NEW MEXICO
ENVIRONMENT DEPARTMENT

**RE: DISAPPROVAL
INVESTIGATION WORK PLAN UP-GRADIENT MKTF WELLS
WESTERN REFINING SOUTHWEST INC., GALLUP REFINERY
EPA ID # NMD000333211
HWB-WRG-18-011**

The New Mexico Environment Department (NMED) has reviewed the *Investigation Work Plan Up-Gradient MKTF Wells* (Work Plan), dated August 2018, submitted on behalf of Western Refining Southwest Inc., Gallup Refinery (the Permittee). NMED hereby issues this Disapproval. The Permittee must address the following comments.

Figure A: Recommended Well Location

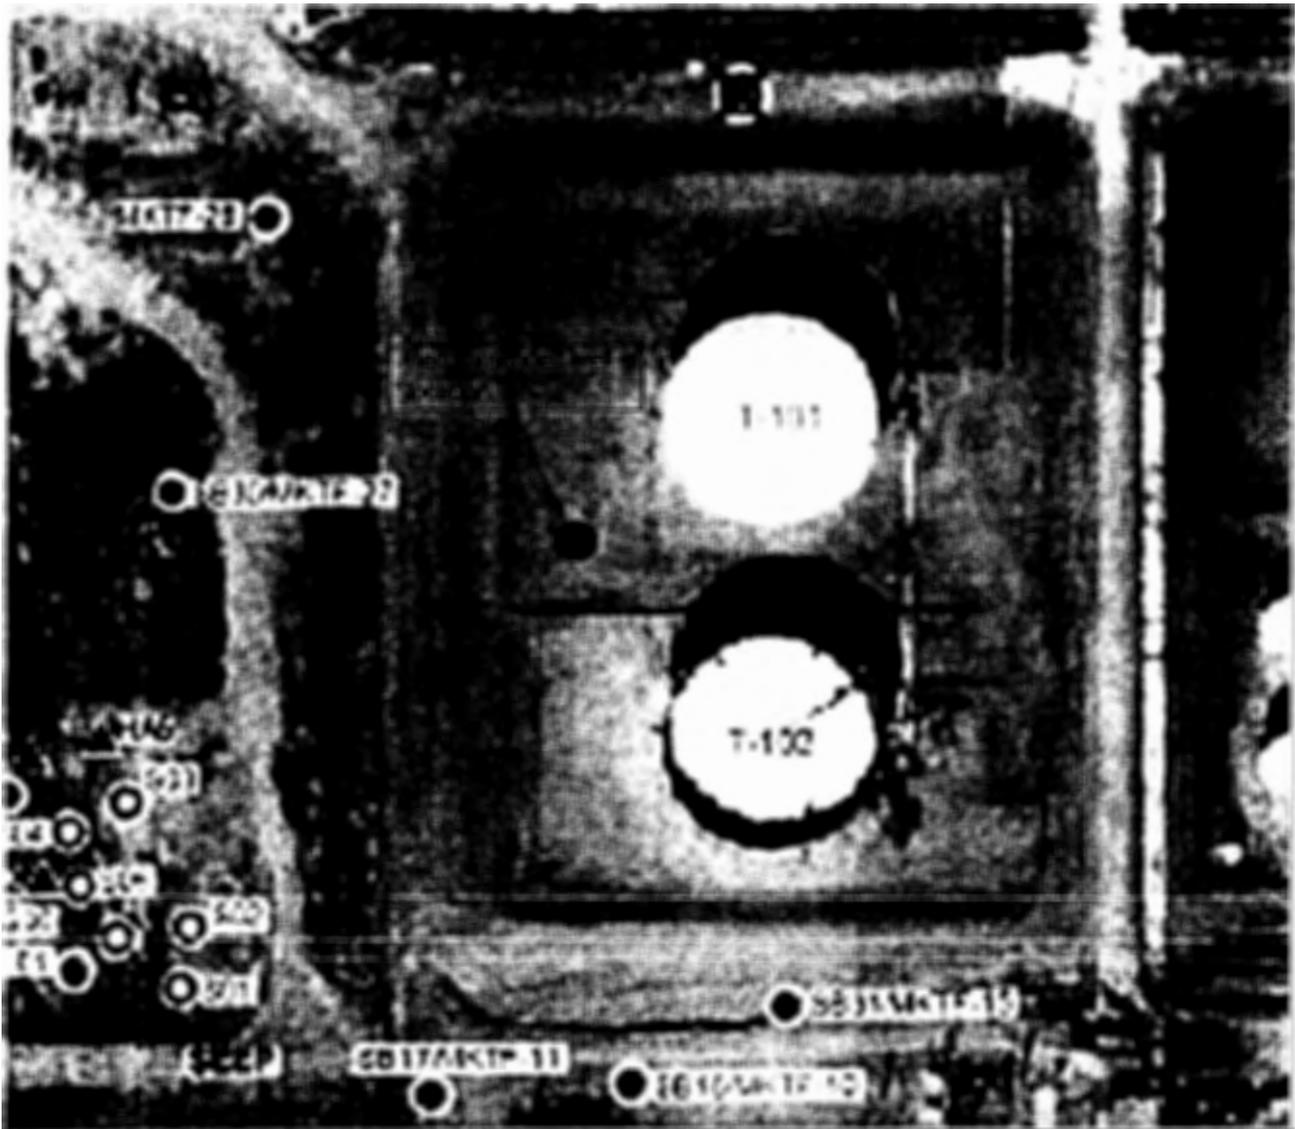
In the *Executive Summary*, page E1, the Permittee states, “[f]our new wells are proposed; one well to the south of monitoring well MKTF-35, a new well to the east of MKTF-37, one well to the east of MKTF-39, and the fourth well on the north side of crude Tank 101.” Comment 24 in the NMED’s *Disapproval for Interim Measures Report Hydrocarbon Seep Area*, dated February 1, 2018 directs the Permittee to investigate the subsurface and groundwater conditions north of Tank 102, rather than Tank 101. The Permittee proposed to install a well north of Tank 101; however, in order to address the comment more accurately, the proposed well must be installed north of Tank 102 and south of Tank 101. A recommended well location is shown on Figure A below:

The Permittee may adjust the final well location shown on Figure A as necessary to avoid underground pipelines and structures but must attempt to install the well as close as possible to NMED's recommended location. The Permittee still must install the proposed groundwater monitoring well north of Tank 101 as shown in Figure 5, *Proposed Well Locations Map*. Revise the Work Plan accordingly.
